**PLANNING BOARD
PORTSMOUTH, NEW HAMPSHIRE**

February 20, 2025

AGENDA

Re: Recommendations for the February 20, 2025 Planning Board Meeting

DRAWING No. **C3**
 SHEET 6 OF 21
 JBE PROJECT NO. 18134.1

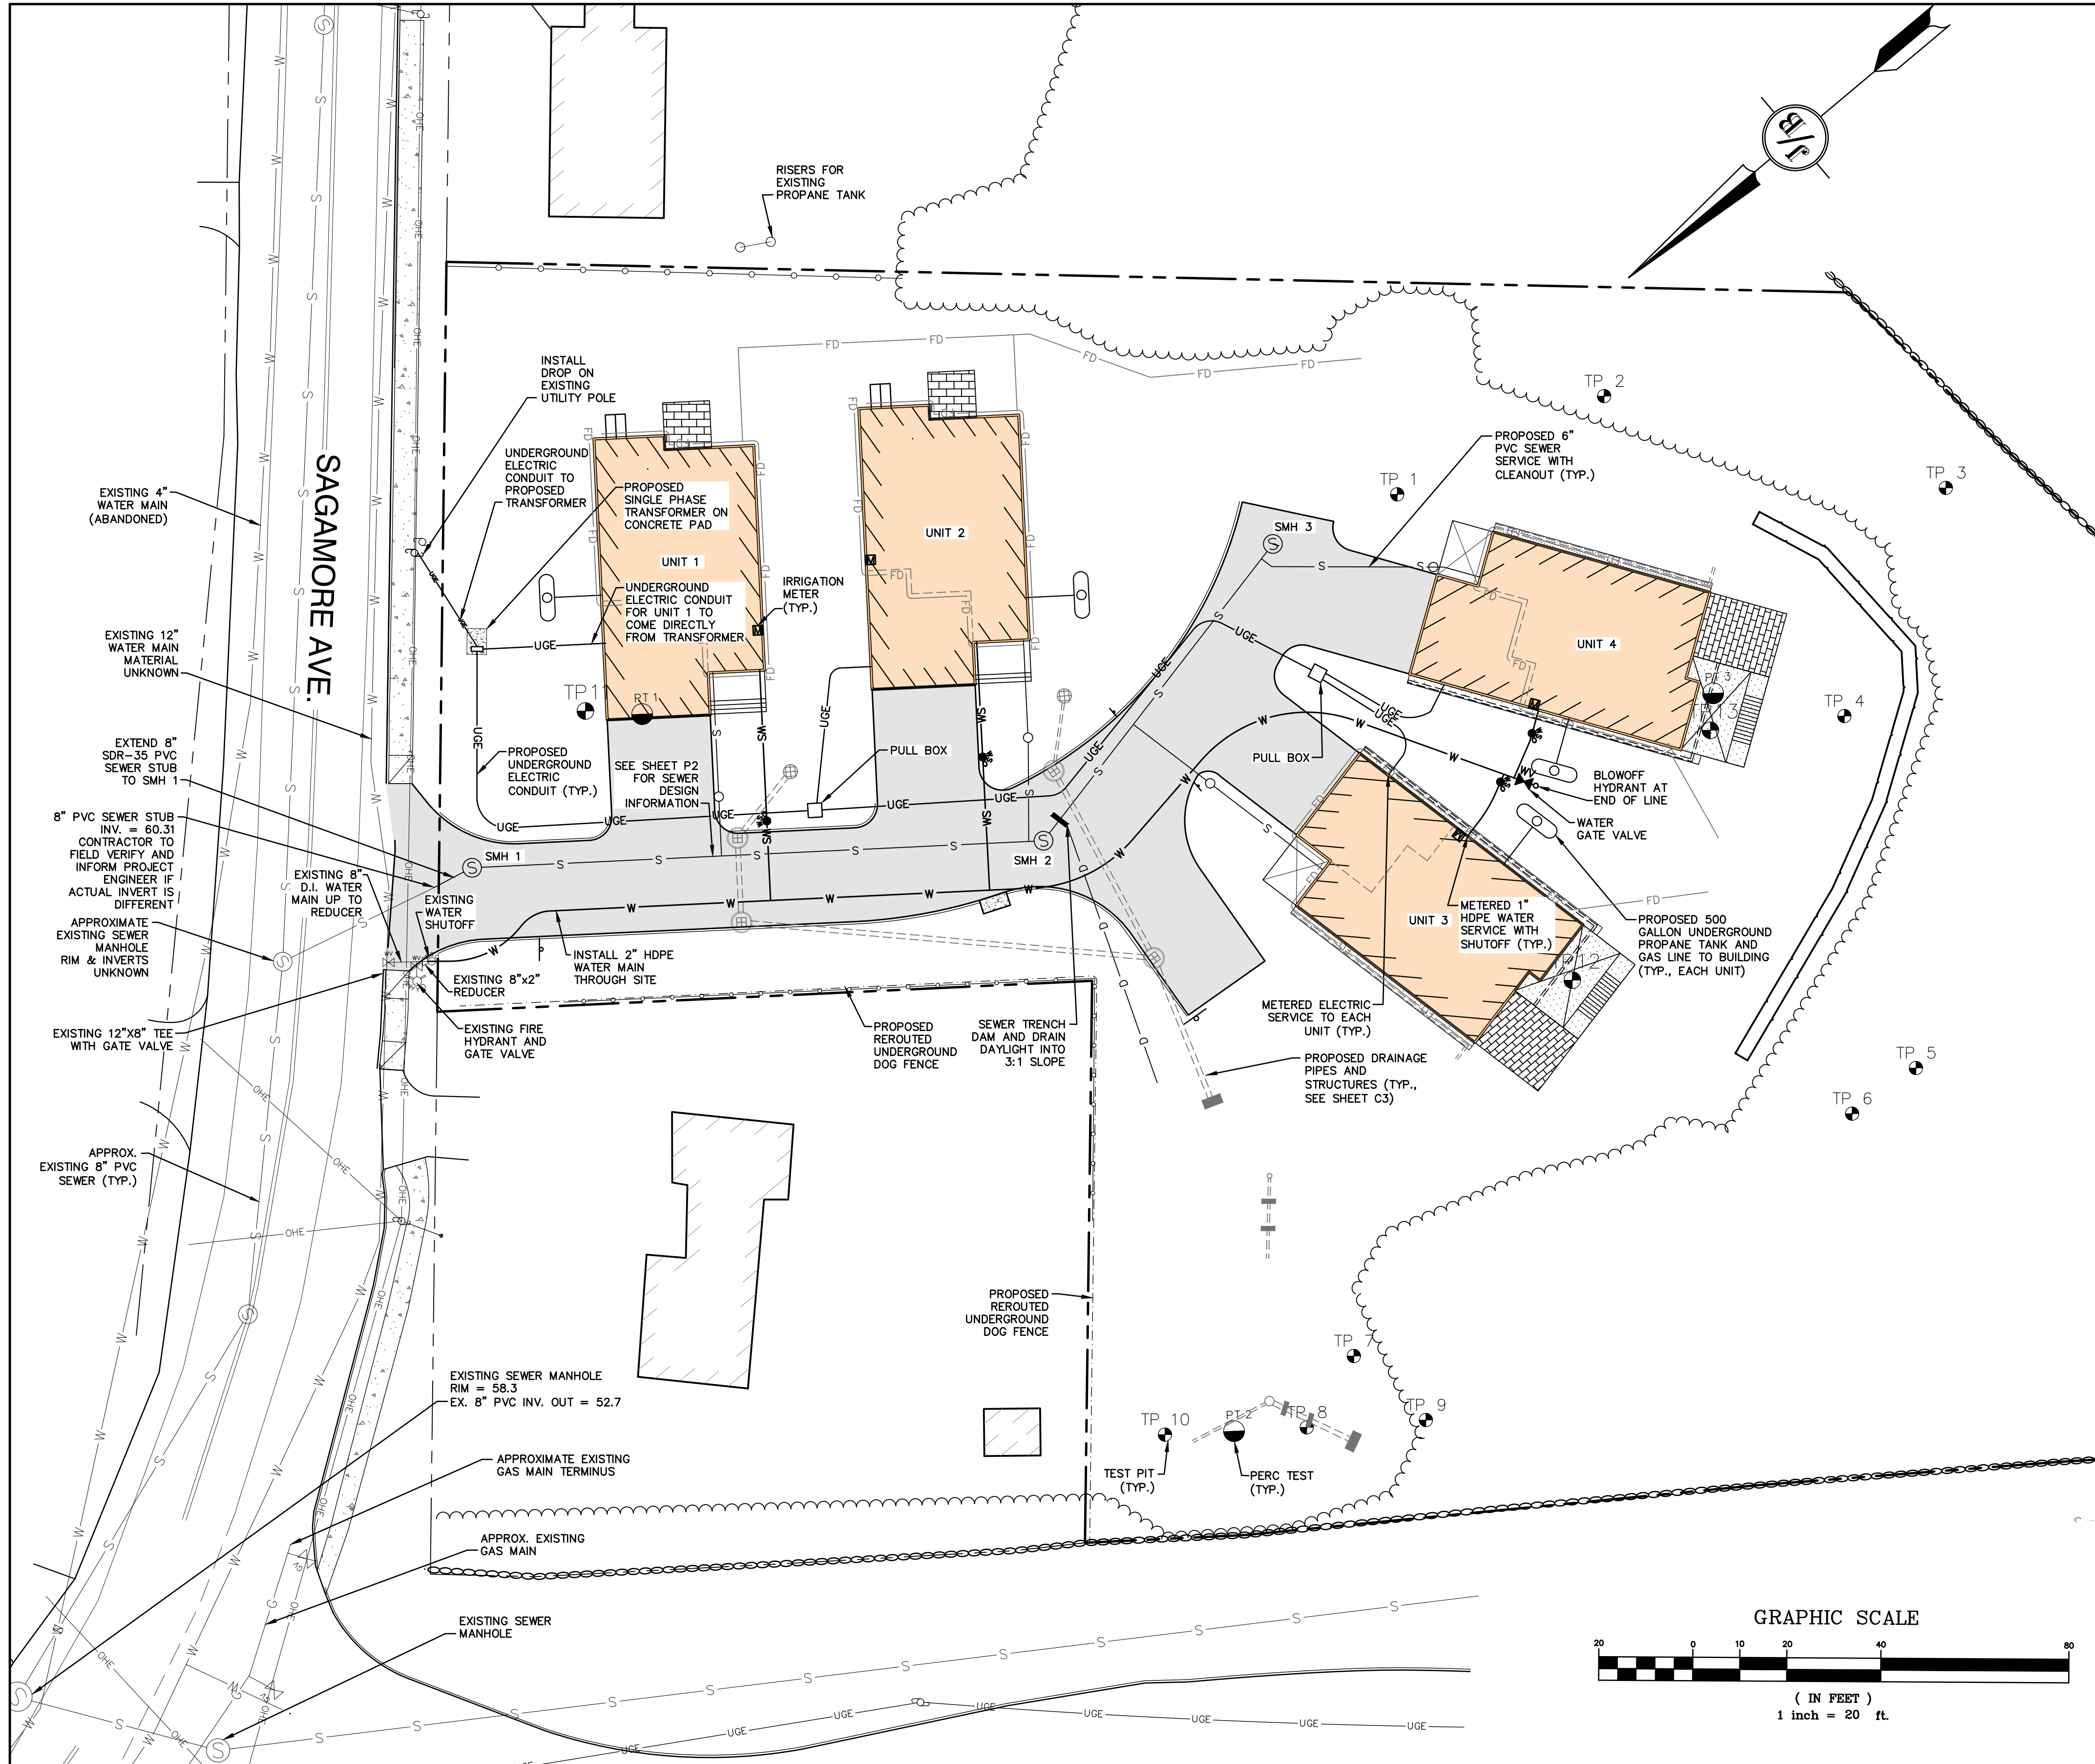
- 2.4) Key elevations should be added to the stone infiltration basins under the decks for Units 3 and 4. Add notes to the plan requiring inspection of the subgrade by the City to ensure that the design criteria is met.

RESPONSE: Specifications for the top and bottom of stone elevations relative to existing grade have been added the labels for the stone infiltration beds on Sheet C3. Additionally, notes have been added to the "Infiltration Stone Underneath Deck" detail on Sheet D5 directing the contractor to remove ledge to at least 2' below existing grade in the footprint of these practices if encountered, and to verify that existing subgrade has not been excessively compacted prior to placement of stone.

DRAWING No.	D4
SHEET 18 OF 21	JBE PROJECT NO. 18134.1

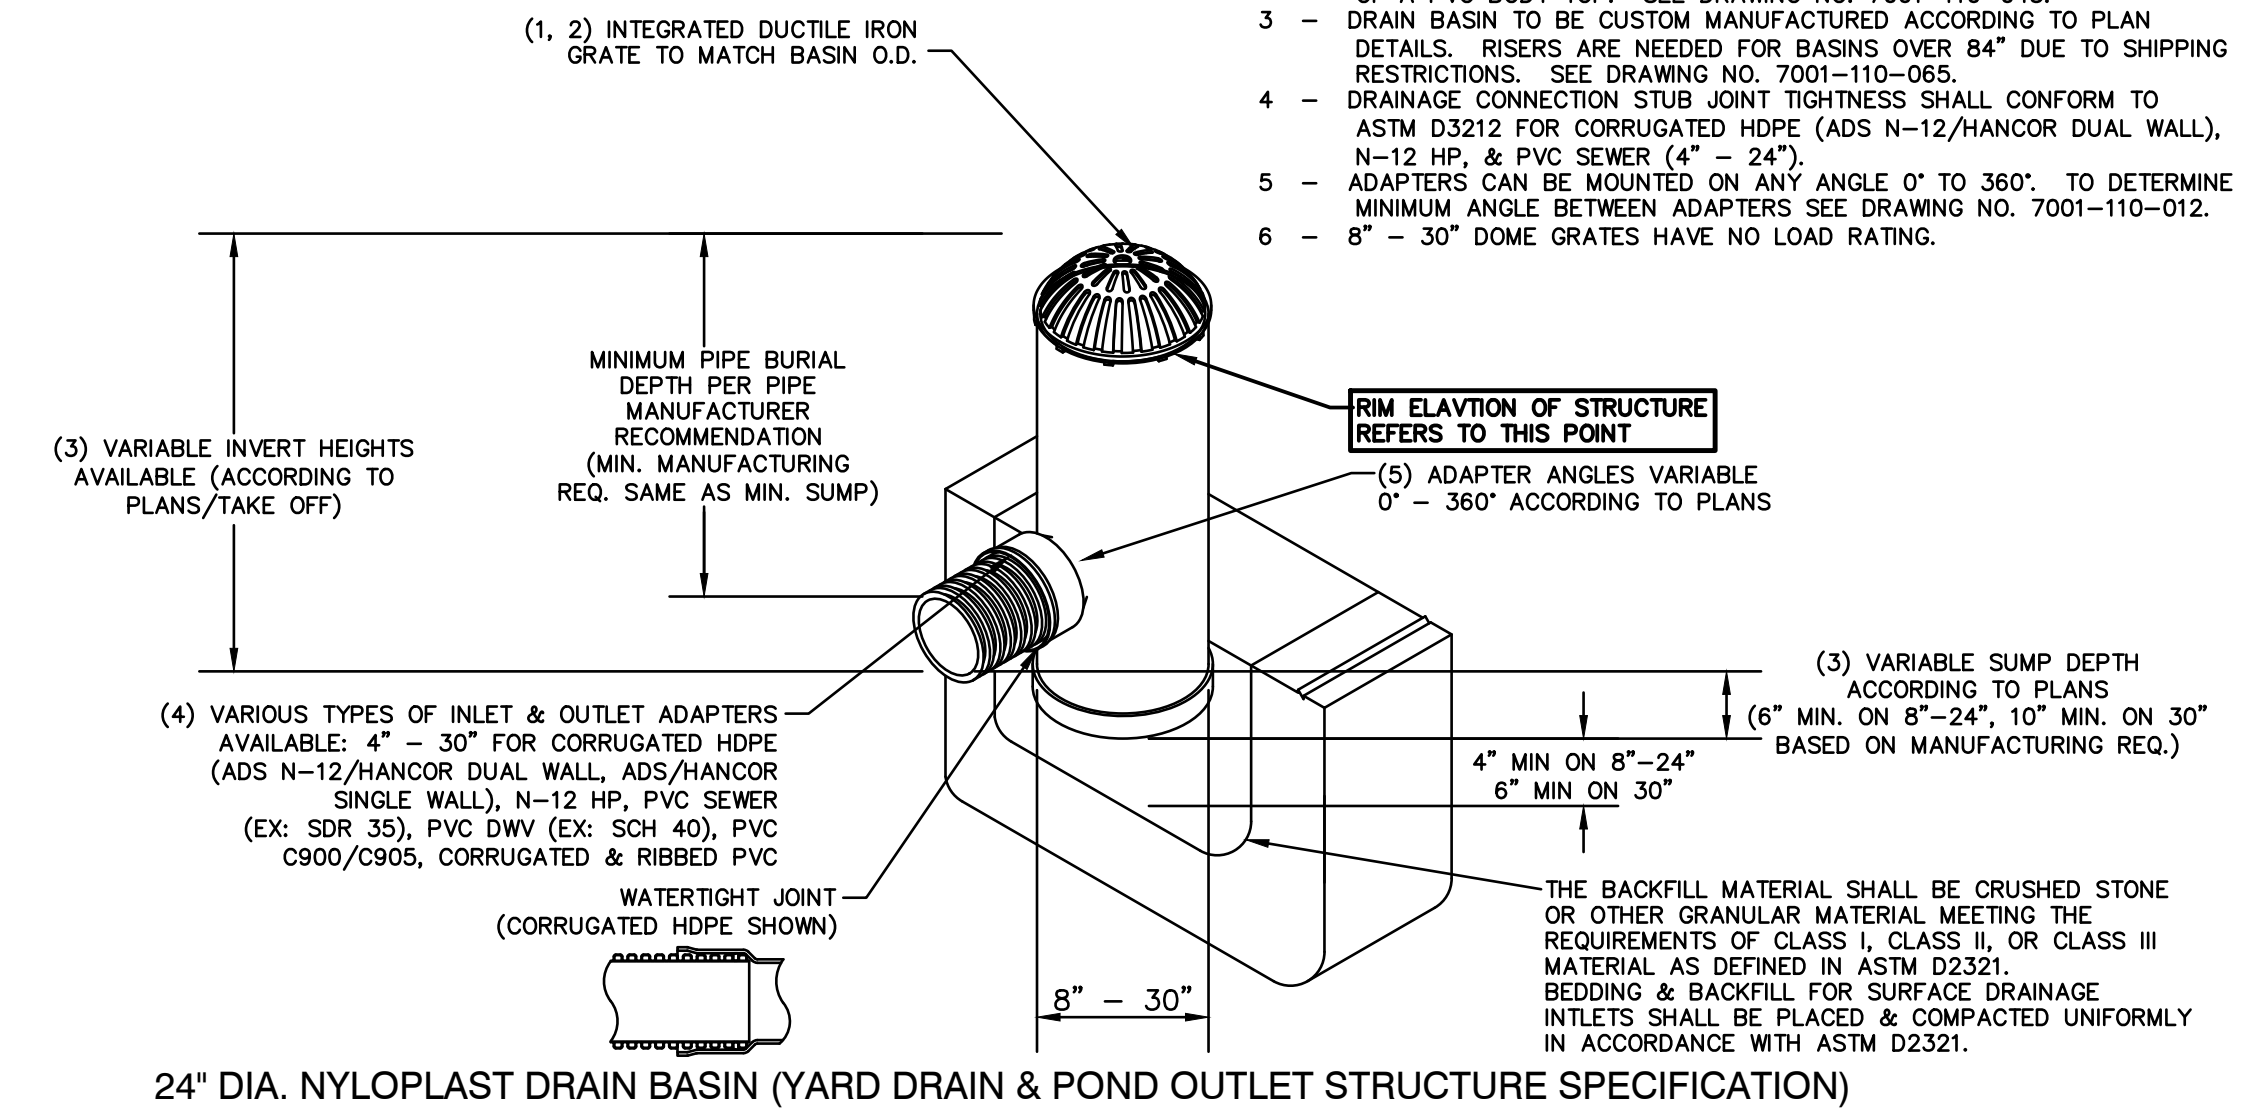
stone underneath deck specify uncompacted in-situ soil or suitable backfill from subject parcel native material is placed beneath and adjacent to the systems. The Designer should provide gradation, compaction, and infiltration rate requirements for the placement of the fill adjacent, below and down gradient of the infiltration practice. The sand absorption area for unit 3 is in 5-foot fill section. The detail should include a minimum depth of native material below the treatment area as well as down gradient.

RESPONSE: Note #4 has been added to the sand absorption area detail on Sheet D4 specifying that a test pit shall be performed prior to construction of these practices in order to confirm adequate separation to ledge, and that ledge shall be removed to at least 12” below the bottom of the practice if encountered.
